# Access Compliance Report

## Public Rights-of-Way

### (Curb Ramps)

Intersection ID: 6170	Main Street: OAKBLUFF_CR	Cross Street: TIMBERBLUFF_DR	Location: SW
ADA ID: 8B1FB4A6CD94	Ramp Type: Directional1	Initial Pass/Fail: Pass	Overall Compliance: No
		Severity Score: 0

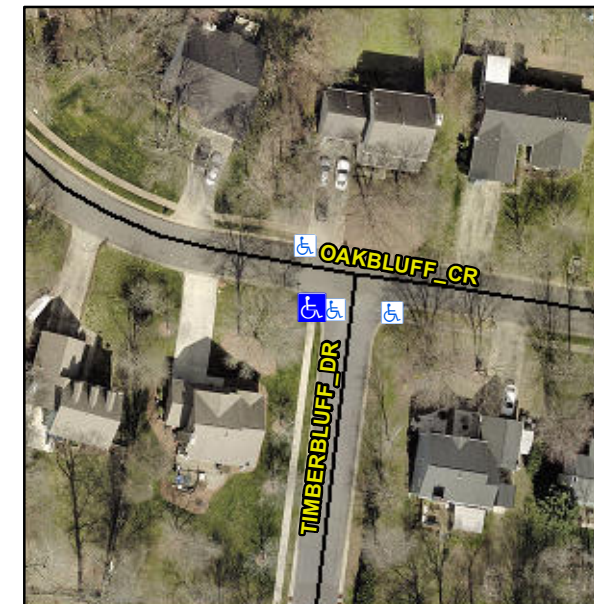
Possible Solutions:

**Remove & Replace Detectable Warning System.**

PROW/ADA:

**R305.2**
